To: Sam Hubbard, Development Planner, Planning and Community Development
From: Deb Pierce, Plan Reviewer, Building Services Department
Subject: Arlington Heights Police Department – New Building – Preliminary Review
PC #: PC 16-024 – Round 2
Date: February 6, 2017

PLAN COMMISSION PC #16-024
Police Station Redevelopment
200 E. Sigwalt St.
PUD Amendment to Ord #78-026
Round 2

AHPD – 200 E. Sigwalt Ave.
PC#16-024
Round 2

Project: 200 E. Sigwalt Street
Police Station Redevelopment

**ALTERNATE "B" FIRE STATION
PCC PAVEMENT, 10" SPECIAL DETAIL**

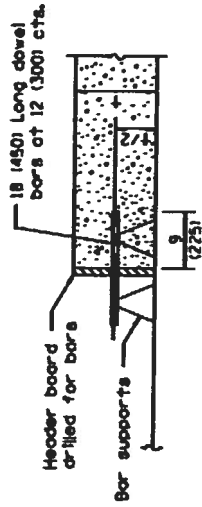
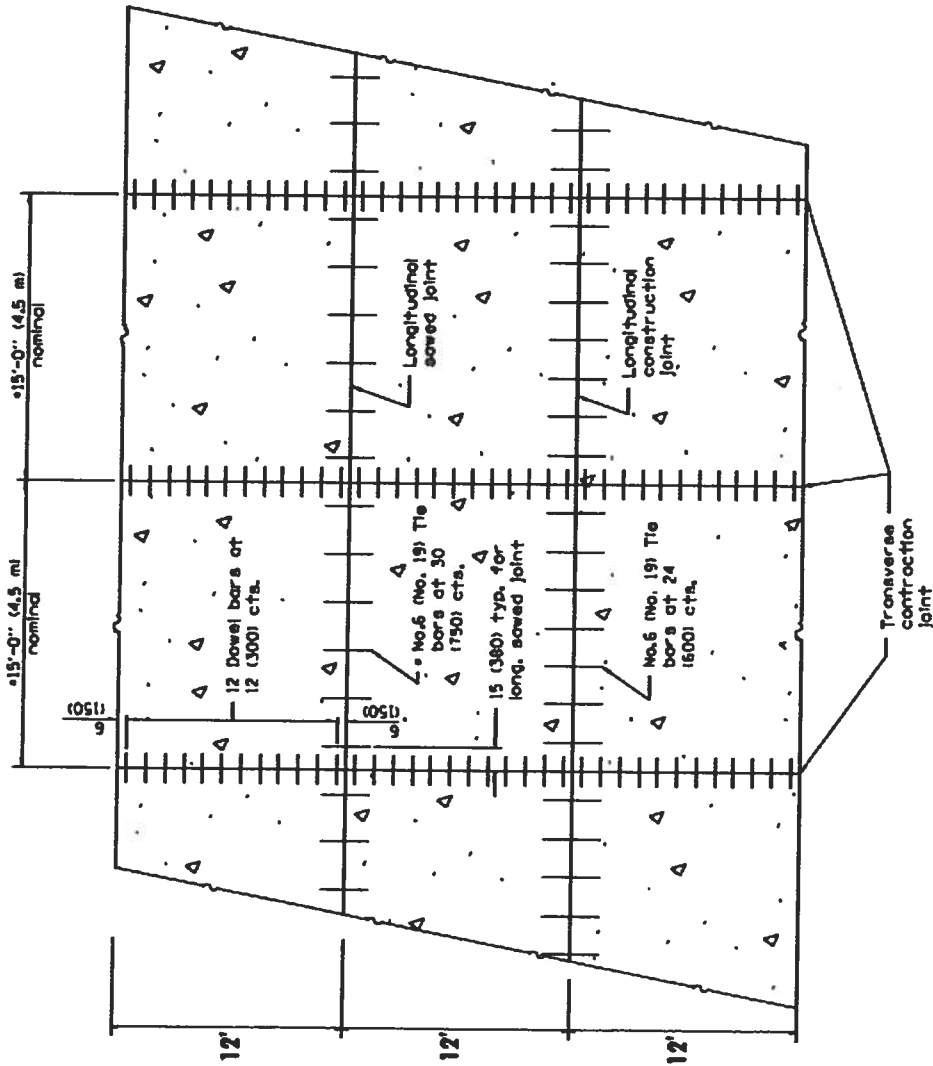
51. The response made by the petitioner to comment #27 is noted. Sheet C-104: The PCC pavement section shall match the recently completed Fire Station 4 concrete driveway pavement section: 10" PCC Concrete, 4" CA-6 Stone Subbase, transverse 1-1/2" dowel bars, longitudinal #6 tie bars. See attached detail.
